## DEVELOPMENT APPLICATION ASSESSMENT REPORT

<b>Application Number:</b>	DA2022/1998
----------------------------	-------------

<b>Responsible Officer:</b>	Thomas Burns
<b>Land to be developed (Address):</b>	Lot 88 DP 13152, 34 Elanora Road ELANORA HEIGHTS NSW 2101
<b>Proposed Development:</b>	Alterations and additions to a dwelling house
<b>Zoning:</b>	C4 Environmental Living
<b>Development Permissible:</b>	Yes
<b>Existing Use Rights:</b>	No
<b>Consent Authority:</b>	Northern Beaches Council
<b>Land and Environment Court Action:</b>	No
<b>Owner:</b>	Paul Christopher Miller Natalie Diane Miller
<b>Applicant:</b>	Turnbull Planning International Pty Ltd

**Figure 1 - non-compliant portion of staircase highlighted in red**

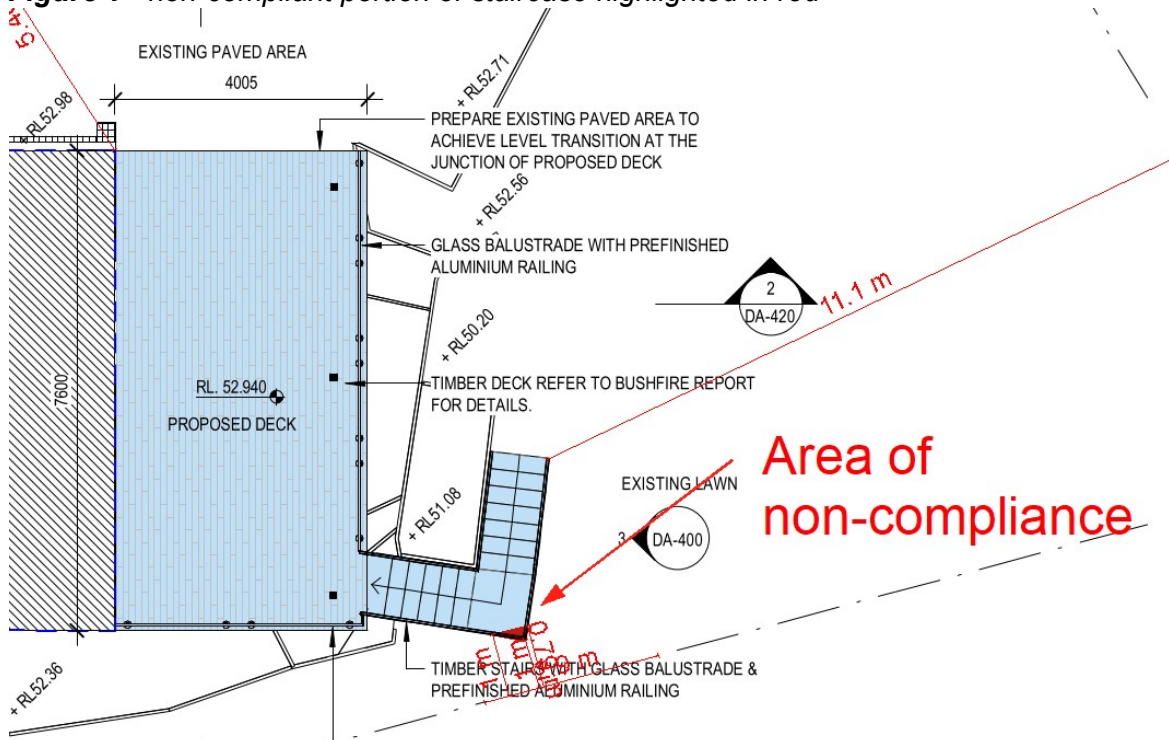
The southern corner of the proposed external staircase that provides access from the proposed ground floor deck to the lawn area is setback 0.79m from the southern side boundary, which does not meet the numeric requirement of 1m. It is important to note that the non-compliant component of the staircase accounts for an area of 0.1sqm. Figure 1 below depicts the area of non-compliance.

The non-compliant staircase is located adjacent to the front yard of the southern adjacent property (30 Elanora Road) and separated approximately 19m from the dwelling on this adjacent property, in turn ensuring that a reasonable level of privacy, amenity and solar access is maintained within the development site and adjoining residential property.

Flexibility has been afforded in this circumstance as the technical breach to the side setback requirement does not result in adverse amenity or streetscape impacts.

Having regard to the above assessment, it is concluded the applicable outcomes of the control have been achieved. Therefore, the application is supported on merit.
